ISSUE: Permit to Demolish/Capsulate (partial)

APPLICANT: Clare and Jen Little

LOCATION: Old and Historic Alexandria District
709 South Lee Street

STAFF RECOMMENDATION

Figure 2 - Visibility from South Fairfax Street

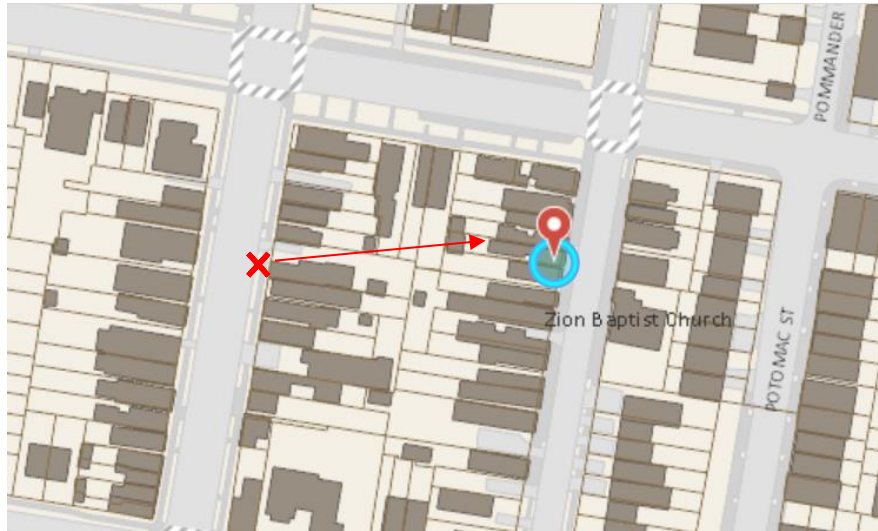
Ms. Roberts asked staff to go over the visibility of the building’s rear. Mr. Conkey showed the only angle that the rear of the subject building is visible from Fairfax Street on a map and picture. Ms. Roberts stated that the existing building is barely visible, but the proposed addition

will be more noticeable. Mr. Conkey clarified that without a visibility study is difficult to predict what portion of the addition will be visible.

Dr. Ossman asked for clarification on the part of the building seen from Fairfax Street, Mr. Conkey explained that the little portion visible in the picture is the existing second story of the ell's west elevation. Mr. West stated that he thinks that what was shown in the picture is the rear of the ancillary building at the rear end of the lot. Mr. Conkey clarified that it was very difficult to determine what portion is visible without trespassing.

The map above shows the only angle from South Fairfax Street from where the rear of the subject property is minimally visible from a public way, approximately 200 feet away. Therefore, staff determined that the rear of the property is functionally not visible, hence not under the BAR purview.

Figure 3 - roof detail

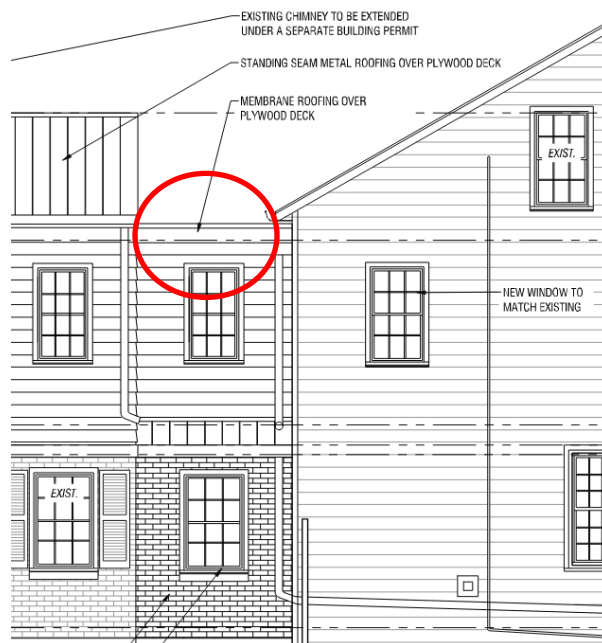
Ms. Roberts asked staff the square footage of the main block roof being demolished. Mr. West said that he did not know the exact amount but roughly 1/3 of the main building's roof will be demolished. Ms. Roberts said that it seems to be more than 1/3 and that she was not comfortable approving the demolition of half of the main block building's roof, building which is apparently much older than stated in the staff report. She stated that she would like to see a better

connection between the addition and the main block where the addition will lightly touch the historic building.

In the March 2, 2022, hearing, the Board was concerned with the amount of historic roof material on the main block being proposed for demolition, even though the rear portion of the roof is not visible from a public way. However, the Board does have purview over demolition permits regardless of the visibility. The project was deferred for restudy to find a better roof solution for the addition that would not require massive demolition of historic fabric. The applicant took into consideration the Board's concerns and adjusted the proposal by eliminating the third story and roof deck initially proposed. The new proposal consists of a second story addition on top of the existing one-story ell. The roof of the main block will not be demolished since the connection will be made by a flat roofed hyphen (Figure 3).

Staff has no objection to the demolition of the existing ell's second story to accommodate a second story addition on top of the existent one-story ell, at the rear of the property. The addition will be functionally not visible from the public way and will not detract from the historic character of the main historic building or the historic district. Furthermore, the Board routinely approves changes on the rear elevations of historic buildings to accommodate a more modern and functional interior layout as tastes and technology evolve. The existing rear elevations do not exhibit a high level of design or architectural detail as well.
